**ITEM #7 - PRELIMINARY PLAT
HANGOVER HOLLOW**

KPB File No.	2026-053
Plat Committee Meeting:	July 20, 2026
Applicant / Owner:	Daniel L. Mumey and Roberta J. Proctor of Anchor Point, Alaska
Surveyor:	Christopher Mullikin; Mullikin Surveys LLC
General Location:	North Fork Road, Anchor Point

STAFF REPORT

HANGOVER HOLLOW

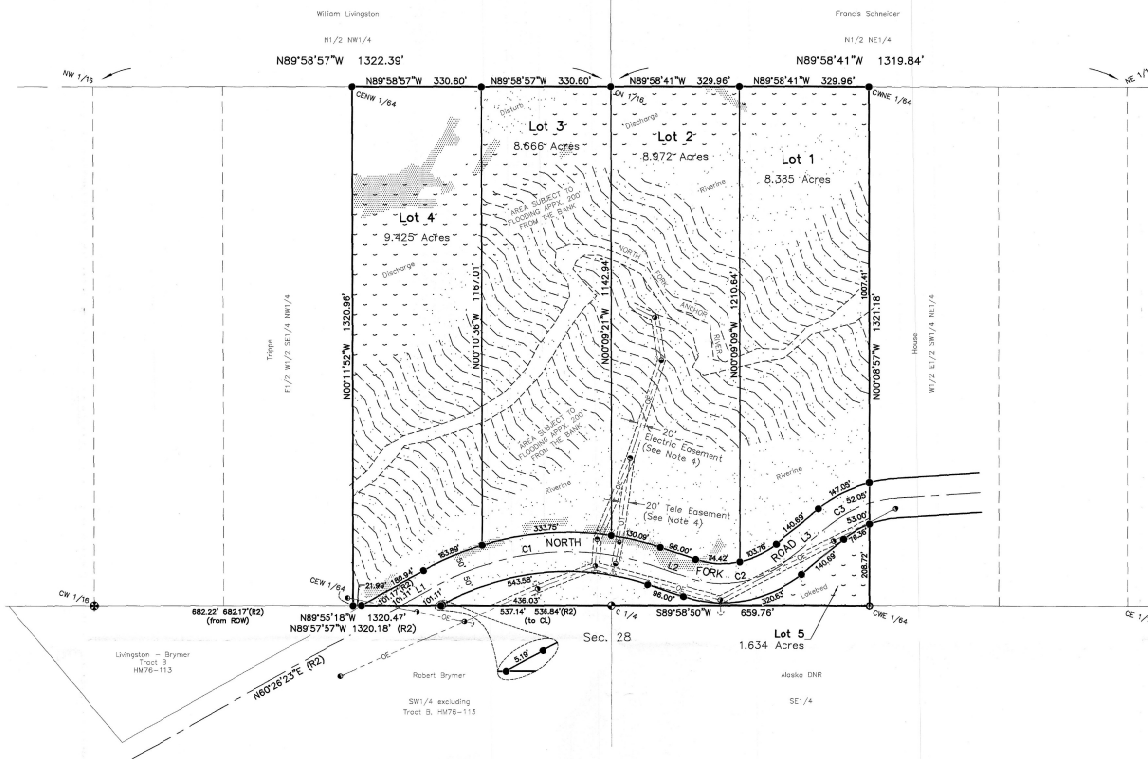
The SOA DOT&PF has requested shared access points for Lots 1 and 2, and for Lots 3 and 4. **Staff recommends** including a plat note on the final plat indicating these shared access requirements.

KPB data indicates a driveway located in the southwest corner of proposed Lot 4 being used for access to the adjacent parcel to the west. An additional driveway on proposed lot 4 appears to provide access for proposed Lots 3 and 2. **Staff recommendation:** granting private driveway easements over the existing travel ways to eliminate encroachments and access issues. Because these easements would be private, **staff recommends** they be created by separate document, recorded, and then shown or noted on the final plat.

Multiple structures are located on the subject parcels. **Staff recommends** the surveyor confirm whether any encroachments exist during the field survey.

KPB River Center Reviewers notes that this area has not been mapped by FEMA for flood information. The preliminary plat includes notes indicating that areas within approximately 200 feet of the river bank are subject to flooding. **Staff recommends** providing the source of this flood-risk information with the final plat and reduce the shading to a hatch line on the drawing with a note flagged to it and a plat note.

A soils report is required for proposed Lot 5, and an engineer must sign the final plat as the new lot is less than 200,000 square feet. The corresponding Wastewater Disposal Note should be added to the final plat and will be reviewed upon submittal of the soils report.

A soils report will not be required for proposed Lots 1 through 4, as each lot exceeds 200,000 square feet. The correct Wastewater Disposal note has been added as plat note 7. **Staff recommends** including the corresponding lot numbers with the wastewater disposal note.

The HEA Land Management Officer has requested modifications to the easements depicted and noted on the plat, as well as additional easements. **Staff recommends** complying with the requests on the final plat. The comment is included in the packet for review.

- Modify the KPB File No to 2026-053
- Modify the Plat Approval date to July 20, 2026
- Correct the minor typo in the Anadromous Water Habitat Protection District Note: "... within the KPB Anadromous Waters Habitat..."
- Add Certificate of Acceptance of North Fork Road to the State of Alaska
-

- The borough will not enforce private covenants, easements, or deed restrictions per KPB 20.60.170(B).
- *No access to state-maintained rights-of-way permitted unless approved by the State of Alaska Department of Transportation.*

- Provide labels for the following: Sections 18, 19, 30, and 31, and Nikolaevsk Road.
- F. The location, width and name of existing and platted streets and public ways, railroad rights-of-way, easements, and travel ways existing and proposed, within the subdivision;
Staff recommendation:
Verify HEA easements listed in CTP.
ROW easement to SOA

- Remove ownership labels from adjacent parcels

- H. Approximate locations of low wet areas, areas subject to inundation, areas subject to flooding or storm water overflow, and the line of ordinary high water. This information may be provided on an additional sheet if showing these areas causes the preliminary plat to appear cluttered and/or difficult to read;
Staff recommendation:
Provide source of areas subject to flooding
- I. Approximate locations of areas subject to tidal inundation and the mean high-water line;
Staff recommendation:
Provide MHW line

- HEA requested modifications to plat and additional easements.
- Confirm if easements listed within CTP affect subdivision.
